NUMBER: 25-001-13 REV. A

GROUP: Emissions Control

THIS BULLETIN SUPERSEDES SERVICE BULLETIN 25-001-13, DATED JANUARY 29, 2013, WHICH SHOULD BE REMOVED FROM YOUR FILES. ALL REVISIONS ARE HIGHLIGHTED WITH **ASTERISKS**** AND INCLUDE ADDITIONAL MODEL YEARS, UPDATED PART NUMBERS, AND SIMPLIFIED DIAGNOSTICS.**

MIL Illumination Due to P2000, P2A00 and/or P2A01

Fig. 1 O2 SENSOR WRAP

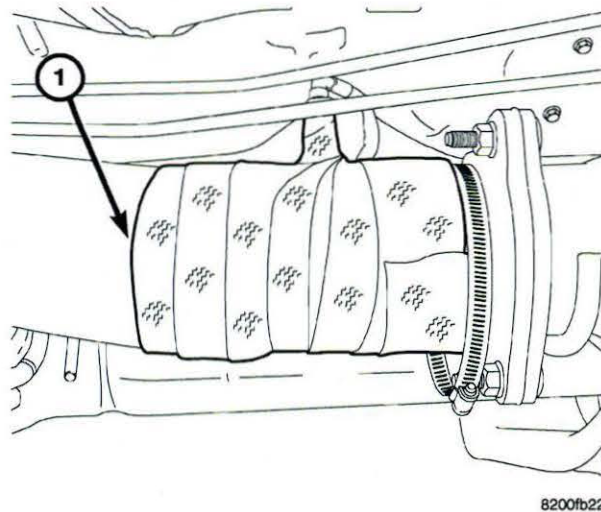
2. Inspect the front O2 sensor area of the exhaust for the presence of either a wrap or blanket (Fig. 1).

-
3. Is there a wrap or blanket around the exhaust pipe in the area of the front O2 sensor?
 - a. YES>>>Proceed to the next step.
 - b. NO>>>Proceed to the Repair Procedure.
 4. Was the wrap/blanket installed properly and is not damaged or torn/tattered?
 - a. YES>>>This bulletin will not address the symptom/condition. Follow the diagnostic information provided in DealerCONNECT>TechCONNECT>Service Info>Group 28 DTC Based Diagnostics>Module, Engine control (ECM), 6.7L>Standard Procedure>PRE-DIAGNOSTIC TROUBLE SHOOTING PROCEDURE, 6.7L or DealerCONNECT>TechCONNECT>Service Info>Group 29 Non-DTC Diagnostics>Drivability - Diesel, 6.7L>Diagnosis and Testing>PRE-DIAGNOSTIC TROUBLE SHOOTING PROCEDURE, 6.7L.
 - b. NO>>>Proceed to the Repair Procedure.**

Fig. 3 O2 SENSOR OLD VERSUS NEW

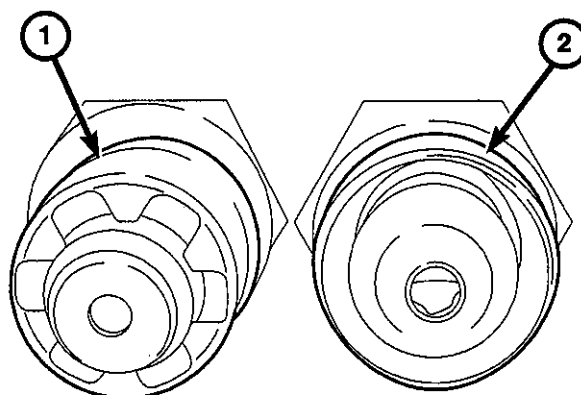
6. Install the exhaust pipe. Refer to the procedures identified in DealerCONNECT>TechCONNECT>Service Info>11 - Exhaust System>PIPE, Exhaust>Installation>6.7L DIESEL for additional information.
7. Inspect both O2 sensors to ensure that the latest sensors are installed in the vehicle. O2 sensors that have p/n 05149263AA (or later) scribed on the sensor, (Fig. 2) are the newer style sensor. If it is difficult to read the part number, the newer style sensor can easily be identified by the soot shield design on the sensor, (Fig. 3).

8. If the oxygen sensor is not scribed with p/n 05149263AA or newer or if the soot shield appears as the older style soot shield (as seen in (Fig. 3)), replace the oxygen sensors with p/n 05149263AA. If the oxygen sensors are to be reused, clean the O2 sensor using shop air only. **Do not use any solvents or cleaners when cleaning the O2 sensor.** Torque to 41 N•m (30 ft. lbs). Connect wiring to both of the Oxygen (O2) sensors.
